Re: PA 10-5825, Prime Wildlife Shorelands Combining District (PW) Preliminary Investigation for proposed subdivision, Idylewood 4th Addition.

Exhibit A
Conditions attendant to PA 10-5825
Preliminary Investigation for the Prime Wildlife Combining Zone (PW)
for 4th Addition to Idylewood

Preliminary Investigation in the Prime Wildlife zone *Staff Report*

PRELIMINARY SUBDIVISION PLAN FOR IDLEWOOD FOURTH ADDITION SUBDIVISION

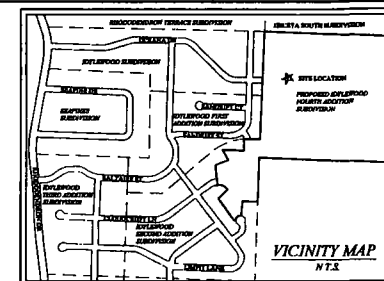
Preliminary Investigation for a proposed 4th addition to the Idylewood subdivision, located within the Urban Growth Boundary of the City of Florence, regarding the Prime Wildlife combining zone pursuant to the requirements of Lane Code 10.245-45. See proposed site plan, Attachment A¹.

Aside from the above rationale, the "pond" is shown (Attachment A) to be contiguous with the remainder of the seasonal lake in the DSL delineation, WD# 07-0747. Wetlands share three primary characteristics: hydric soils, hydrophytic plants, and prolonged water saturation. The fact that DSL has designated the "pond" as contiguous with the remainder of the designated wetland lake adds reason to also include it into the PW zone.

SOUTH HECETA JUNCTION SEASONAL LAKES

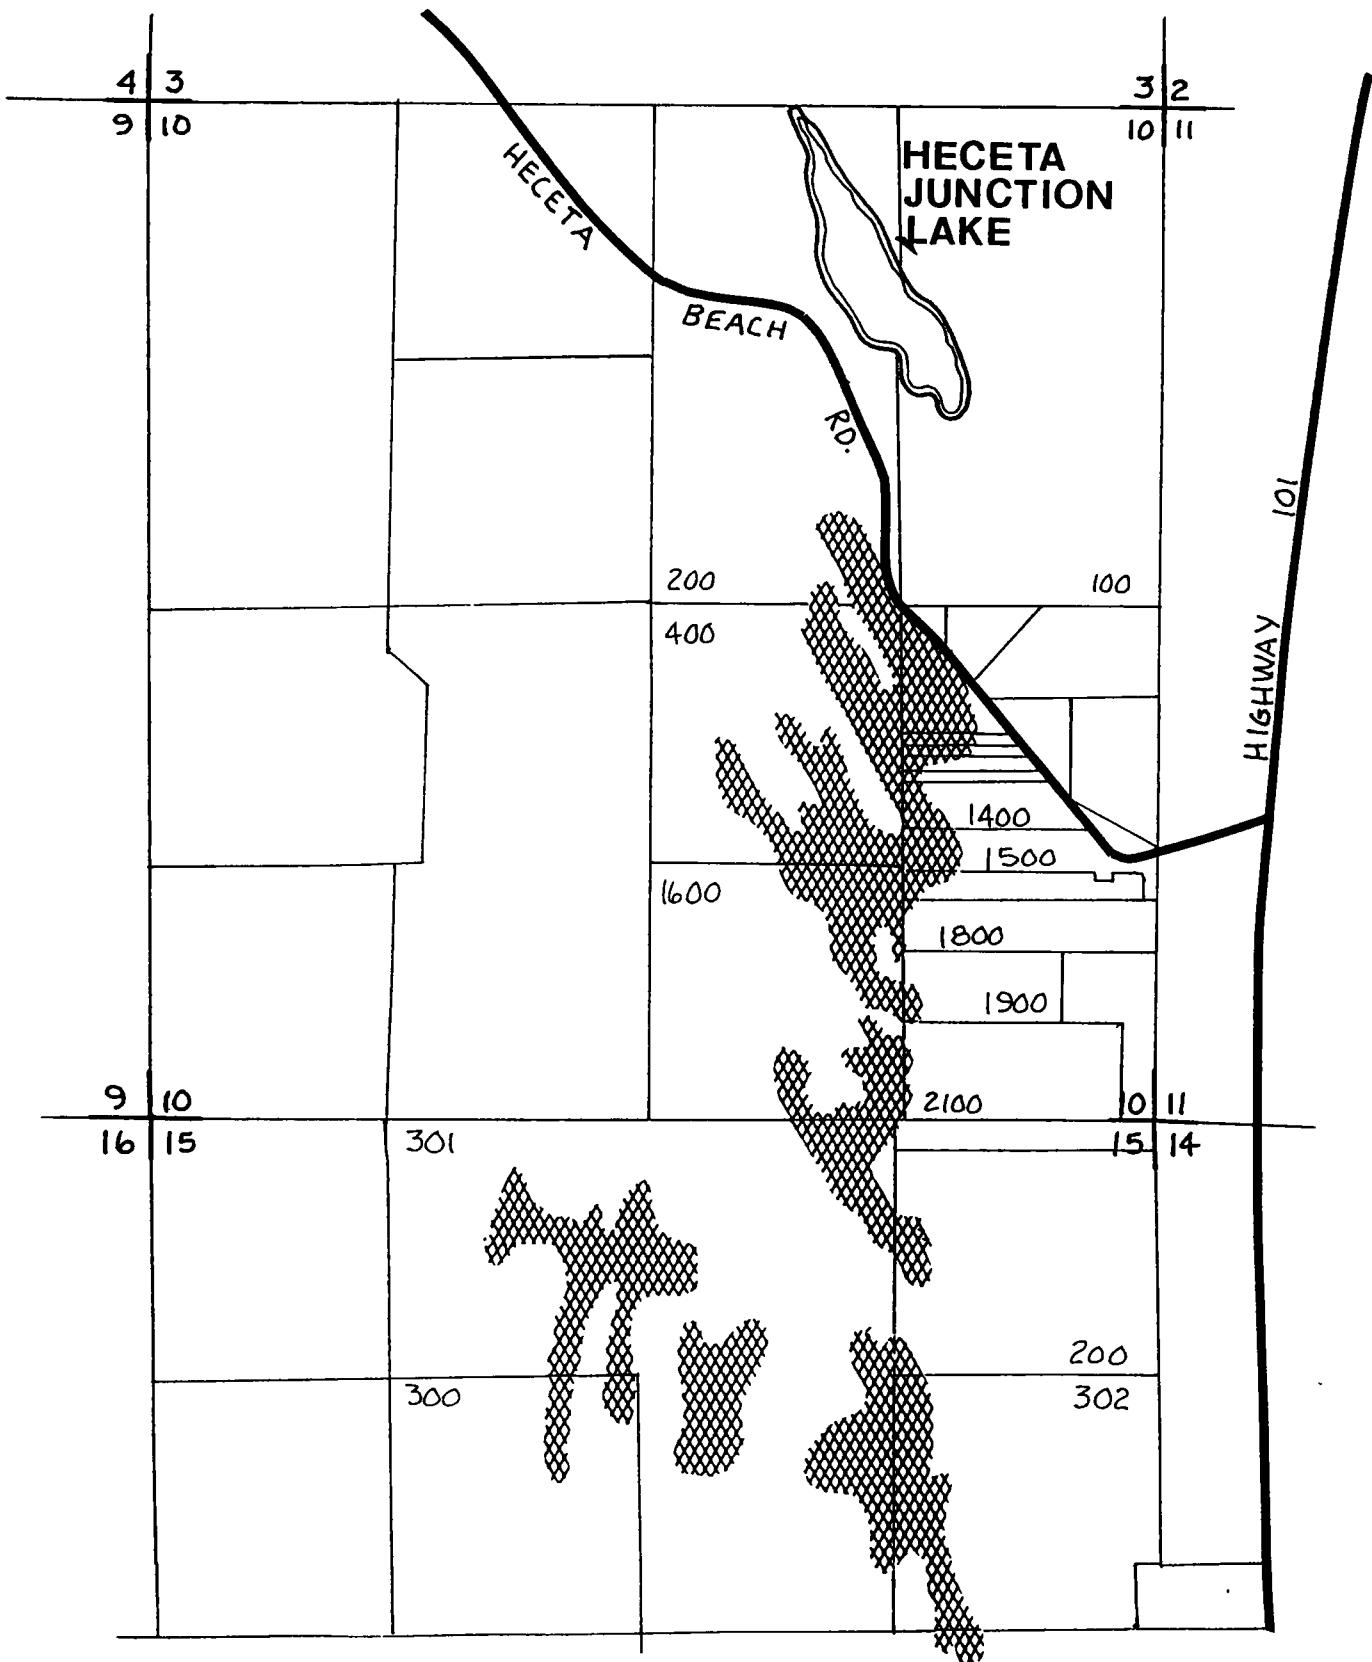
Page 86 of the CSMP refers us to "the 1,000 scale map" for location of these five seasonal lakes. That map is found as Attachment B to this report.

IDYLEWOOD 4TH ADDITION
COASTAL OVERLAY SETBACKS
14 MARCH 2012
FLORENCE, OREGON

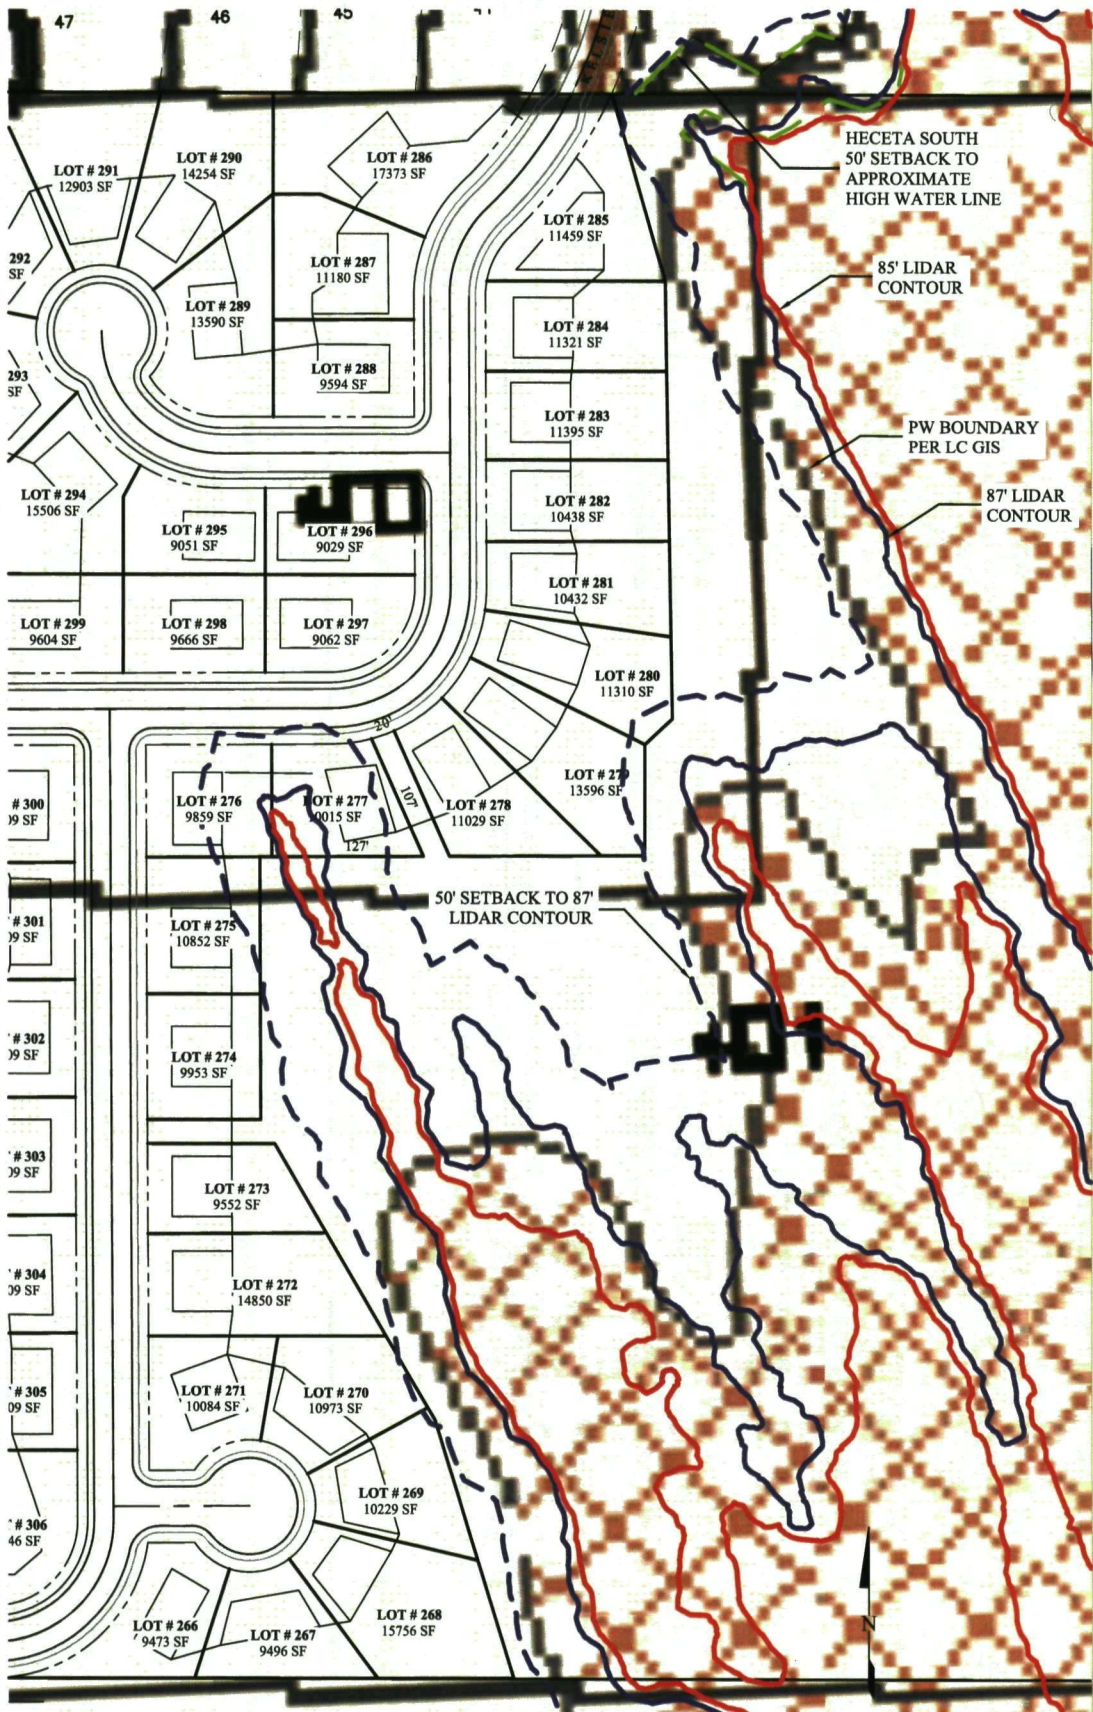
A comparison of Attachments A and D show that the majority of the seasonal lake along with the 50' buffer will have no consequence to proposed development of the property, except for two areas.

The first area is at lot #285. Lane Code Chapter 15/Roads requires that Kelsie Way be extended southward to connect with Oceana Drive. During the review of the Heceta South subdivision, the extent of the PW zone was set at the "approximate high water line" as so marked on that plat, Attachment C to this report. The 50' buffer required by LC 10.245-30(5) was also established accordingly, and no development was permitted to occur inside that buffer. The outer perimeter of lots 30, 31, 33-43 of Heceta South were set accordingly to be outside that buffer. In addition, Kelsie Way was also set enough to the west to be outside the buffer and allow for its construction. According to documents submitted by the agent for this investigation, the "approximate high water line" on the Heceta plat equates to a calculated elevation of 87' msl.

The second area is found proximate to lots 275, 276, and 277 of the proposed Idylewood 4th addition, an area where an arm of the seasonal lake extends towards those lots. Refer to Attachment D. This attachment shows an extended "pond" area (in red) which is detached from the main arm and covers

The question arises as to whether or not the aforementioned “pond” which is found near proposed lots 276, 277 should be included in the PW zone. As seen on Attachment D, it connects to the main lake body

when water is at 87' msl but not when the water level is at 85' msl. Unlike the portion of the lake near the border with Heceta South subdivision, there are no steep embankments at this location. However, at the (accepted) 87' msl, this "pond" is contiguous with the main body of the lake. In addition, at the 87' msl level this "pond" qualifies as land lying between the mean high, high water and mean low watermark of coastal water body.

1. The PW boundary is set at an elevation of 87' mean sea level (msl) around the seasonal lake as illustrated in Attachment D (note: 87' msl = "87' LIDAR Contour" on that attachment). Note: this boundary is independent of the wetland delineation (WD#07-0747) approved by the Oregon Division of State Lands (DSL). Actions within the designated wetlands are subject to approval by the DSL.

2. No structures shall be allowed within 50' upland of the above boundary (measured horizontally, LC 10.245-35).
3. No topographic modification shall occur within 50' upland of 87' msl. PW boundary (measured horizontally). There is no variance option to this standard. (LC 10.245-30(5)).

The PW boundary has been established at 87' msl around the seasonal lake as illustrated in Attachment D. Conditions safeguarding this resource are listed in Exhibit A.

5th wettest March on record for Eugene

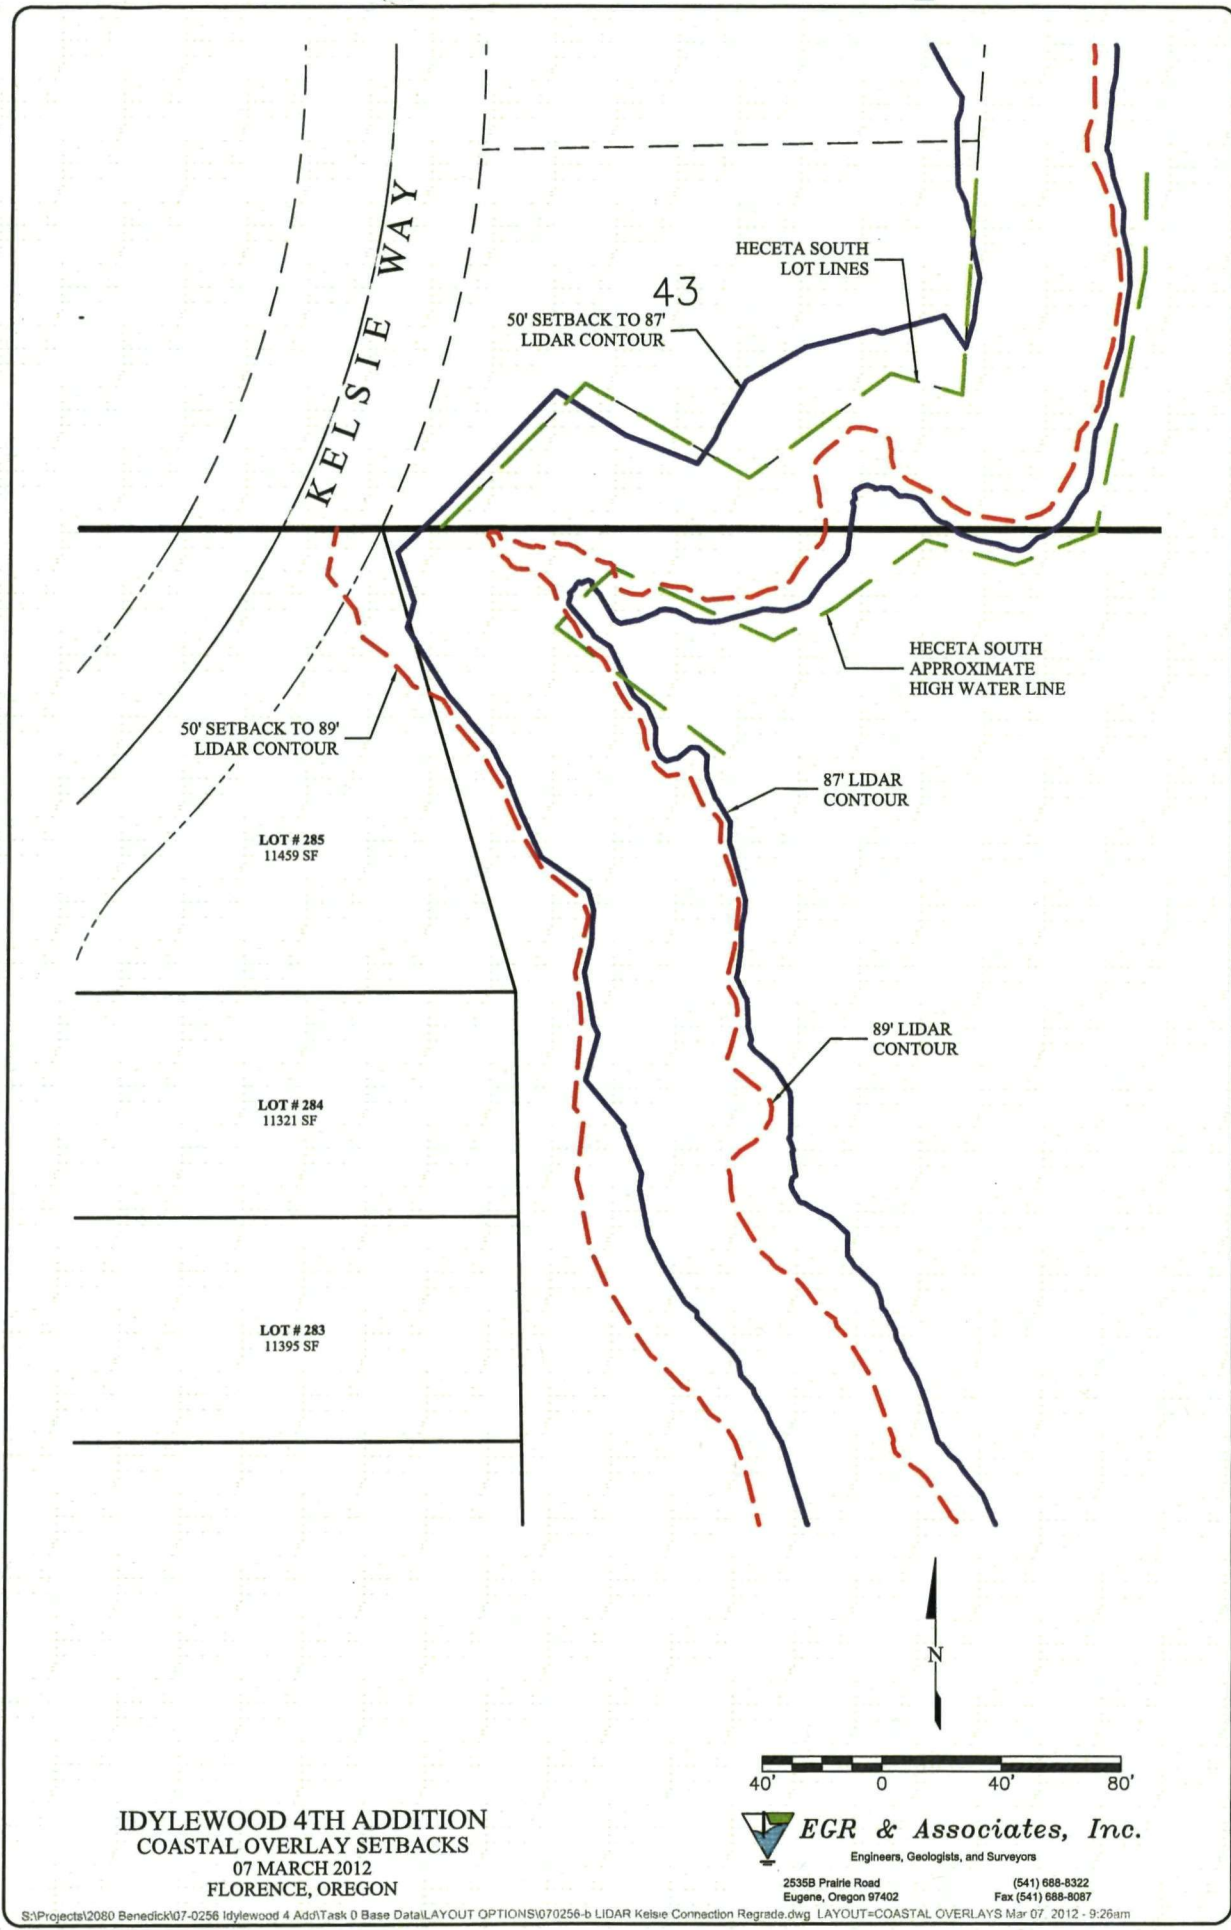
portions of lots 276 and 277. This “pond” raises the question as to whether or not it should also be considered part of the PW zone (it is noted that in any event the pond is part of the DSL accepted wetland delineation, WD 07-0747). A photo of the “pond” is found as Attachment E. The photo was taken from the north end of this feature, looking southward. The water in the pond was observed to be approximately 6” deep on that date. While staff did not traverse to the southern extent of the pond, small trees and brush could be observed at the southern end, verifying that the pond is somewhat separated by the main arm of the seasonal lake, at least during portions of the year, enabling such growth. The photo was taken on 3-29-12, the end of the month of March, which was the 5th wettest on record for Eugene at 9.94” (records for Florence were not available, but is generally greater than Eugene). Source: <http://www.kval.com/news/local/5th-wettest-March-on-record-for-Eugene-145700645.html>). See Attachment F.
